TECHNICAL SERVICE BULLETIN

Transmission Not In Park Message When Driving Below 10kmph

26-2159

This bulletin supersedes 25-2160. Reason for update: Add/Remove/Update Symptoms/Summary/DTCs, Add/Remove/Update Vehicle Qualifiers/Models, Add/Remove/Update Vehicle Model Years, Add/Remove/Update Production Dates, Add/Remove/Update Parts/Part List, Revised Service Procedure (TSB/GSB) / Text (SSM)

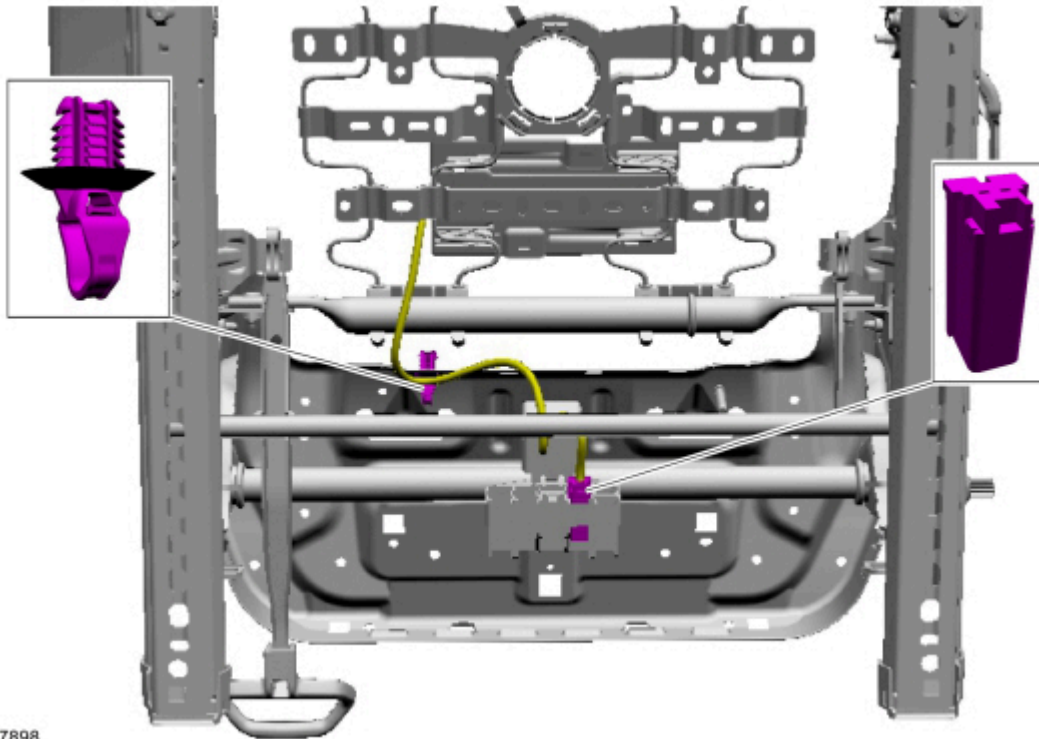
1. Install a new seat occupant sensor **and** front seat cushion foam (see Parts Required). For additional information, refer to 2024 Transit Custom / Tourneo Custom Workshop Manual Section 501-10A.
 - Make sure that the edge clip is located at the indicated position. If required, move the edge clip away from the seat occupant sensor channel in the foam (approximately 40-50 mm).

- Install a new seat heater mat (see Parts Required). The installation of the plastic bracket under the suspension mat is required. Refer to section: **Plastic bracket - Installation**

E467191

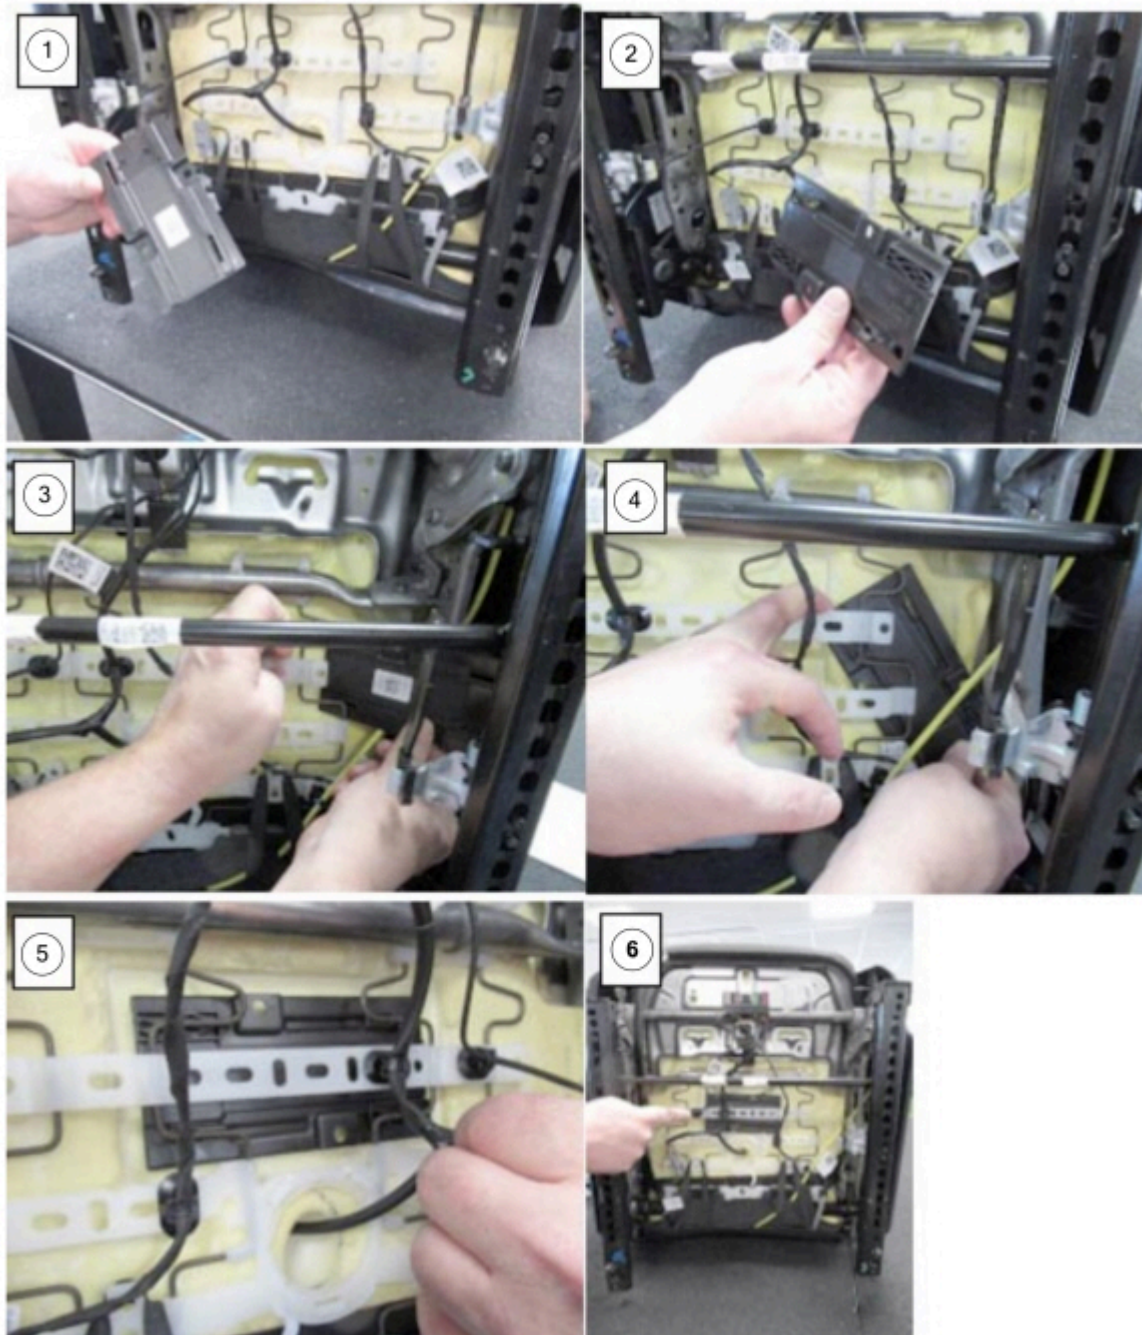
1. **NOTE: In order to install the plastic bracket, the front seat does not have to be removed or disassembled.**

By installing the plastic bracket (see Parts Required), which increases the stiffness of the suspension mat, consequently increase of the sensitivity. The bracket can simply be slid from below under the suspension mat.
